DEVELOPMENT APPLICATION ASSESSMENT REPORT

Application Number:	DA2021/0317
----------------------------	-------------

Responsible Officer:	Gareth David
Land to be developed (Address):	Lot 2 DP 833902, 141 Riverview Road AVALON BEACH NSW 2107
Proposed Development:	Construction of a dwelling house
Zoning:	E4 Environmental Living
Development Permissible:	Yes
Existing Use Rights:	No
Consent Authority:	Northern Beaches Council
Delegation Level:	DDP
Land and Environment Court Action:	No
Owner:	Uday Bhaskar Bonu Kavitha Bonu
Applicant:	Key Urban Planning

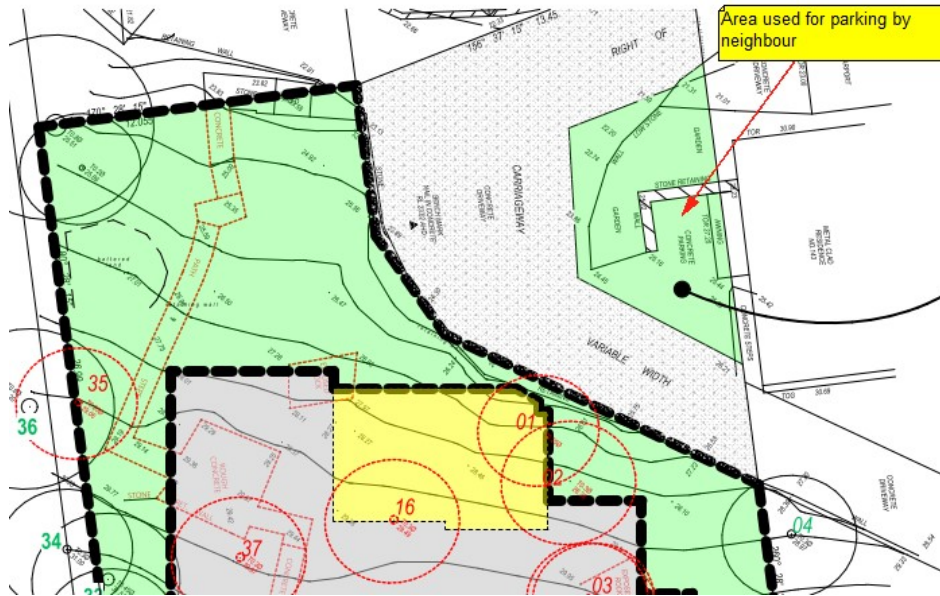
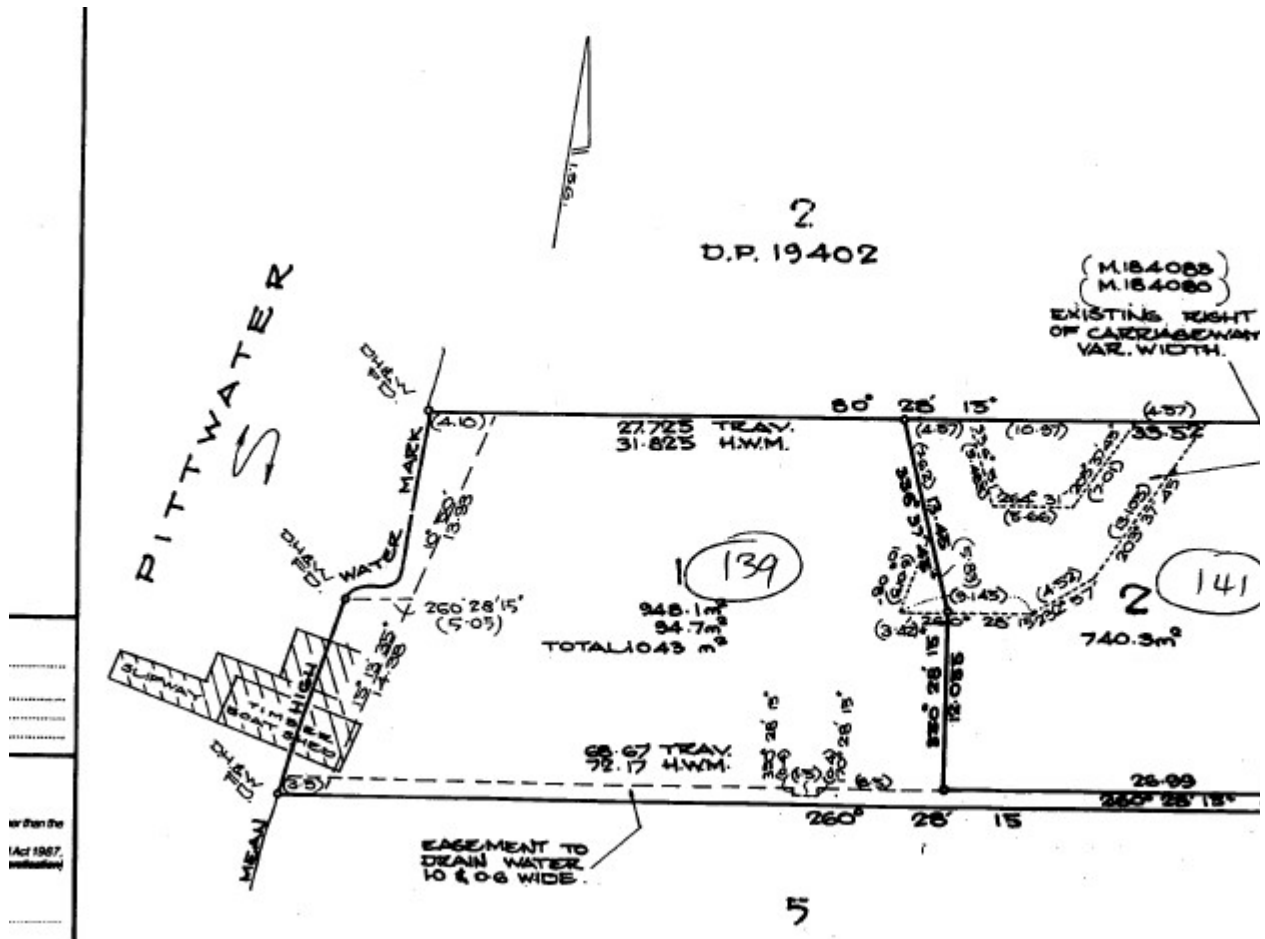
The amended plans show this access turned into a green landscaped area resulting in the loss of access to our parking. There is already some greenery on this corner but increasing it will block our only access which we have had for over 50 years.

The image below indicate the area of concern which is located between the curved right of

carriageway and the northern boundary of the subject site (adjoining No.143 Riverview Road)

The applicant contends that this area of the subject site occupied by the neighbour's car parking space is an unauthorised construction. A review of the survey plan and Council's records do not appear to permit right of use (parking) or access on this specific portion of land of the subject site (i.e between the right of carriageway and No.143 Riverview Road southern boundary). This is shown historical tile documents below:

Council’s Planner wrote to the objector (No.143 Riverview Road) requesting proof of right of use and access on this portion of the subject site; however, this was not provided. Site access will still be afforded to this neighbour via the western most portion of right of carriageway (located on the north-western boundary of the subject site).

4.3 Height of buildings

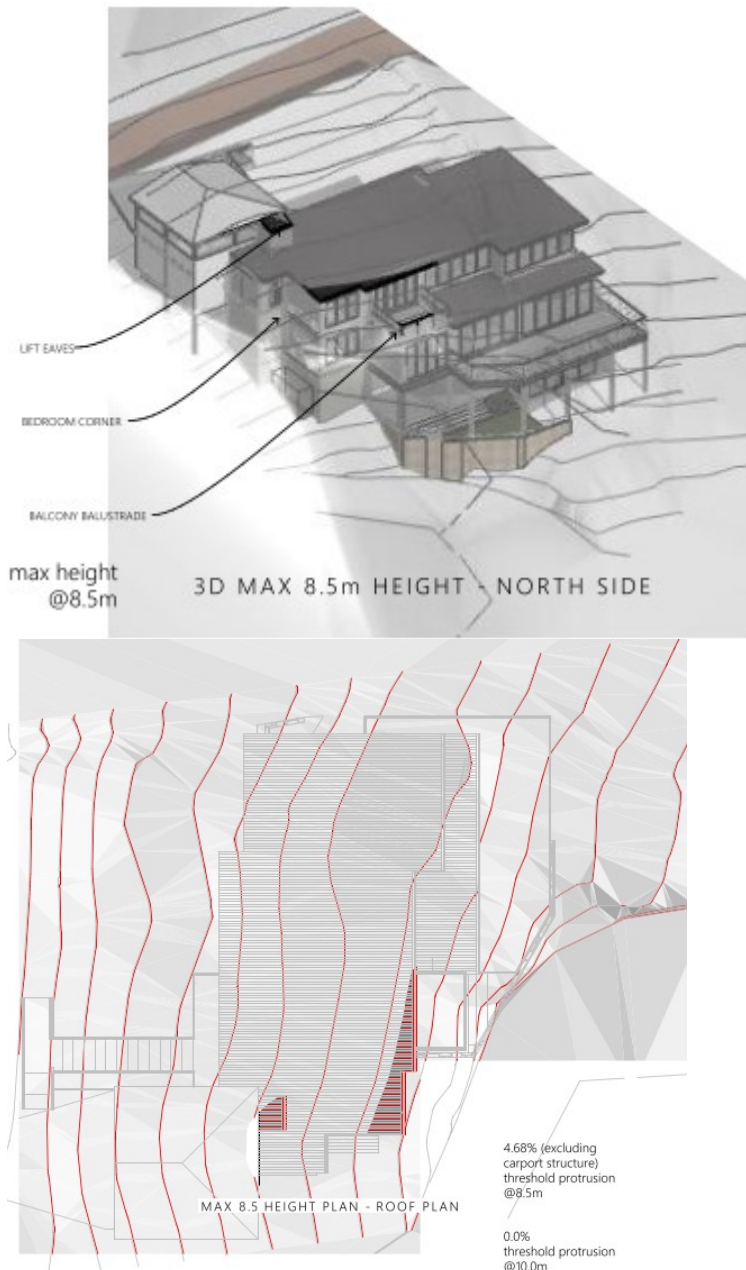
The proposed dwelling has a maximum building height of 8.9 m which does not comply with the 8.5m requirement.

The variation to the 8.5m height limit is not excessive and is demonstrated in Figure 1 bellow. As shown the extent of the variation is predominantly limited to the roof form.

Figure 1 - Proposed building envelope non-compliance on the northern elevation (highlighted in green).

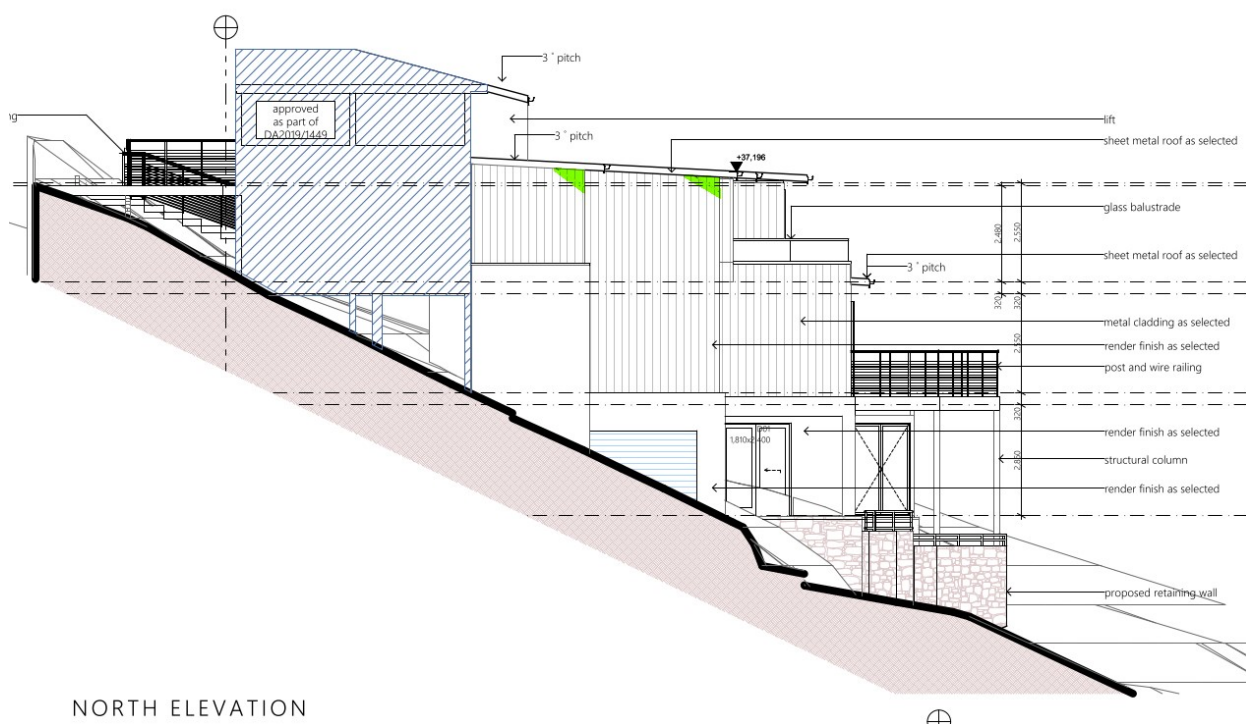
The clause stipulates that buildings are to be projected at 45 degrees from 3.5m above the existing ground level, measured from the side boundaries.

The proposed dwelling has a minor encroachment into the prescribed building envelope along the northern and southern elevations. This variation is represented in figure 1 and 2 below.
